## ***Interactive comment on “Prevailing climatic trends and runoff response from Hindukush–Karakoram–Himalaya, upper Indus basin” by S. Hasson et al.***

**Anonymous Referee #2**

Submitted to: Earth System Dynamics Discussion Manuscript No. ESD-2015-12

**Fig. 1.** Delineation errors. Figure A is manuscript's Figure 2 at Page 648, while B is zoomed part of Figure A.

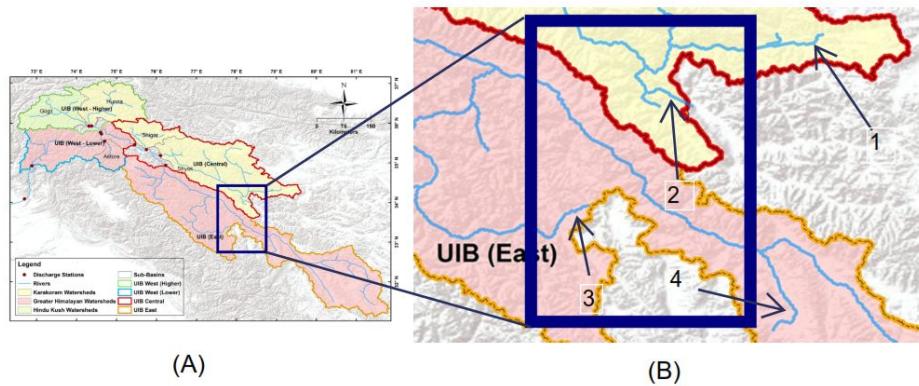
3. During delineation of a watershed boundary the stream network (particularly the start point of a stream) is generated based on either flow area (or number of cells draining to a downstream cell). This provides a stream network, well within the basin's boundaries. This provides nearly a uniform distance of stream network from the basin's

boundary. However, the stream network provided in Figure-2, page 648 does not provide nearly uniform distance from the exterior basin's boundary. In no case a stream should cross the basin's boundary (except at the basin's outlet), whereas near to the eastern part of the Shyok basin the stream 2 in following Figure B (zoomed part of Figure 2, page 648) crosses the outer basin's boundary. Similarly, stream 3 also nearly touches the boundary. The distance between boundary and streams is significantly variable (see streams 1-4, following Figure B). All this makes the delineation of the UIB doubtful. The authors need to address this issue, and have to carry out a re-delineation, together with a revision of the Figure.
